Westinghouse Electric Corporation

July 6, 1964

U. S. Atomic Energy Commission
Washington 25, D. C.

SUBJECT: AEC License SMB 353

EXHAUST SYSTEMS FOR THORIATED TUNGSTEN

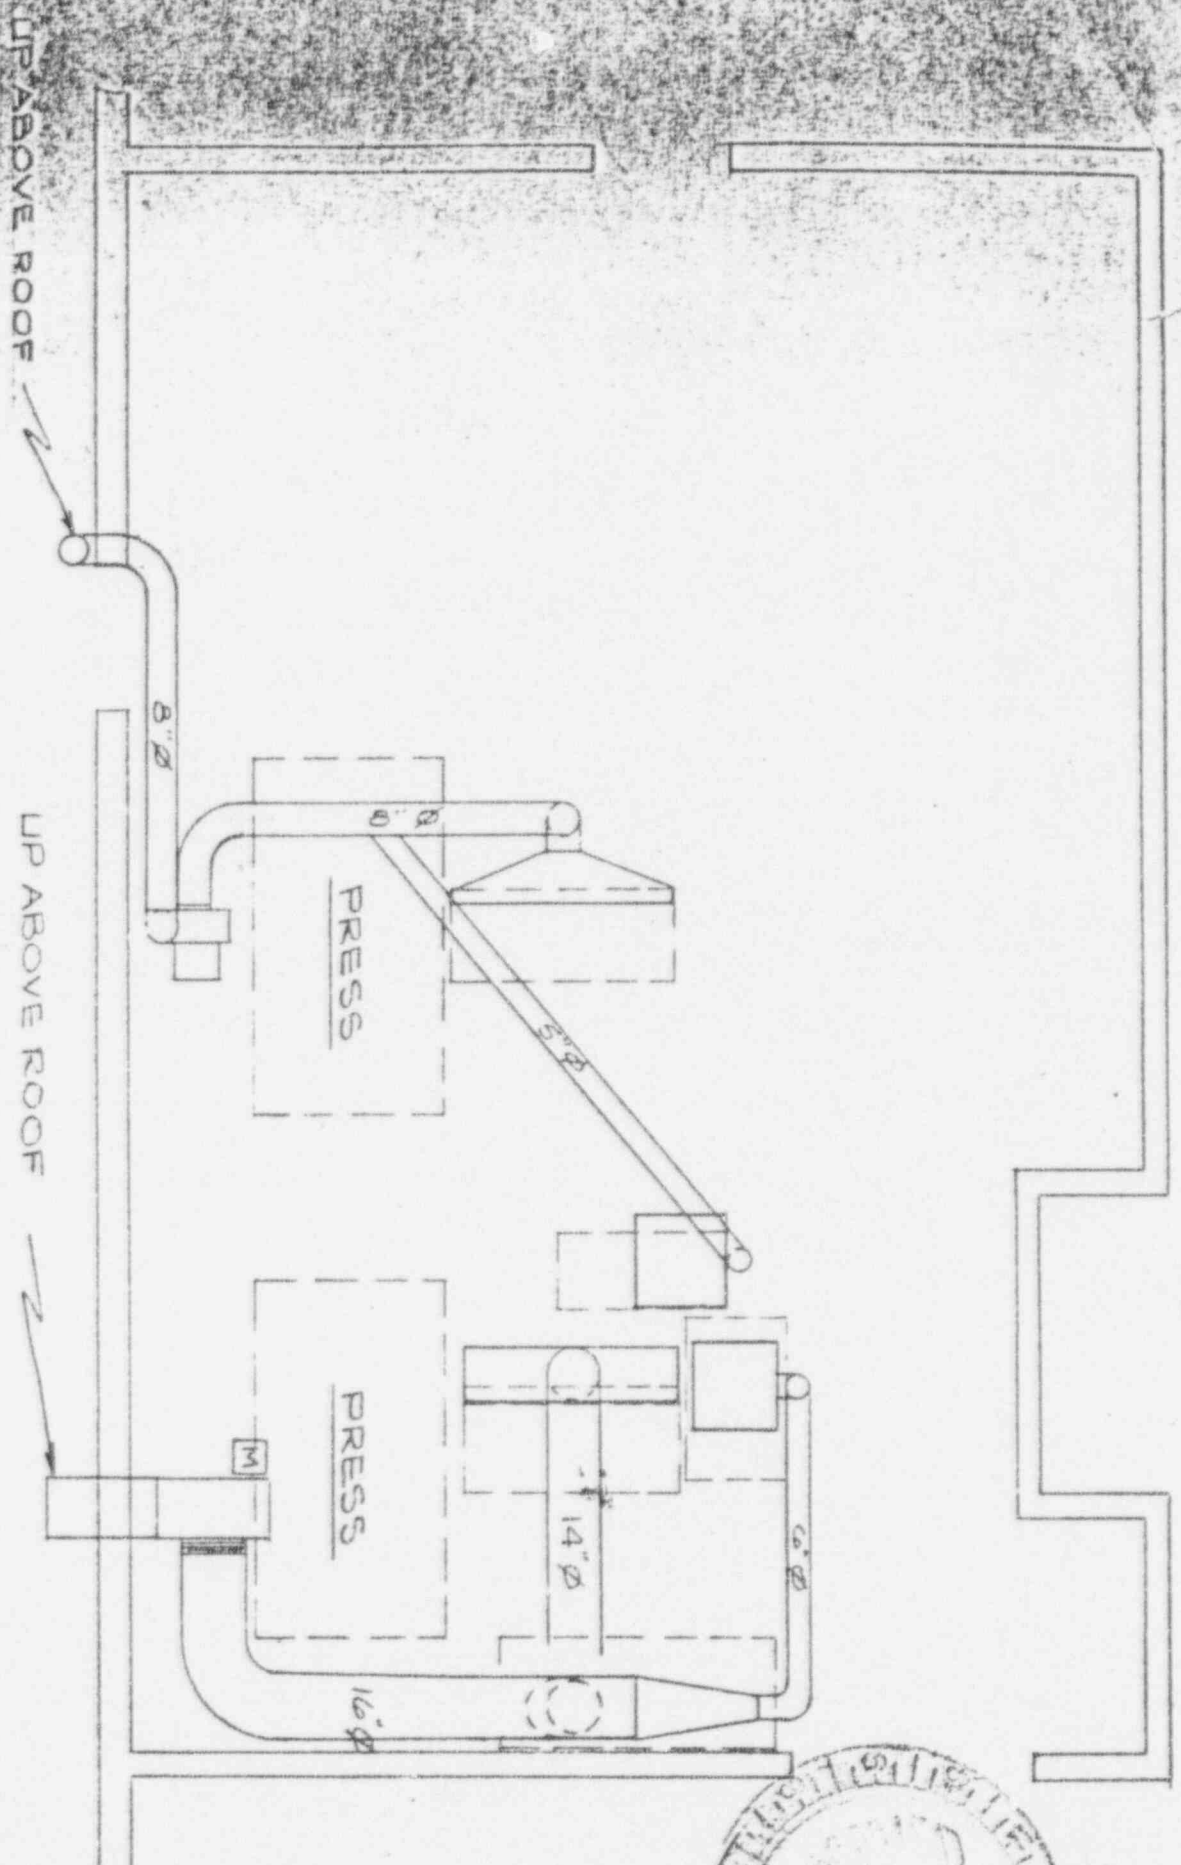
A. Drawings AA 231DS-7, 231GG-18, and B260BX-138 picture the areas in which thorium oxide is processed to make thorium rod or sheet. Thorium oxide is weighed at Area E in an exhausted hood with a velocity of 100 fm (drawing 231DS-7). It is then moved to Area C where it is washed with acetic acid, water rinsed, and oven dried (same drawing). The hood in Area C has a velocity of 100 fm. The material is then transferred to the press room, shown on drawing 260BX-138, where it is pressed into ingots. Following pressing, the ingots are returned to Area C where they are vacuum sintered. The velocity of the furnace hood is 100 fm. It is then ready for shipment to customers or is moved to the rolls (Area D), where it is rolled into the desired sheet size. This operation is performed infrequently. During the past 2 years only about 5 per cent of one man's time was spent in the processing of thorium oxide.

B. Thorium nitrate is processed in the areas shown in drawings B260BX-141, 138, and 137A. In Area 4 (drawing 141) a bag of thorium nitrate is mixed with water for an hour. Air velocity for exhaust system at the mixer is 100 fm. At Area 5 (same drawing) tungsten oxide and the solution of thorium nitrate is mixed and dried under vacuum in the PK blender. Exhaust hood at blender has a velocity of 100 fm. The dried doped oxide is roasted (Areas 7 and 8, same drawing). Air velocity of hood at entrance to furnace is 250 fm; at the discharge end it is 100 fm. After roasting, the oxide is crushed at Area 9 (same drawing). Air velocity at crusher is 350 fm.

After crushing, the oxide is transported to building 6, Area 3 (drawing 137A), where it is transferred to boats under a hood. Air velocity at hood is 250 fm. It is then passed through at the reduction furnace, Area 2 (same drawing).

The oxide is unloaded under a hood, Area 3A (same drawing), air velocity 250 fm. Following the unloading, it is sieved into cans at Area 1 (same drawing), air velocity 200 fm. It is then brought back to building 9 and blended in blender, Area 6 (drawing 141). It is then stored in Area 16 (drawing 138), in special cans in a roped off, clearly marked area. When the metal is to be pressed, it is brought to the press room and sieved at Area 12 (same drawing), air velocity 100 fm. It is then pressed, Area 14 (same drawing), into an ingot.
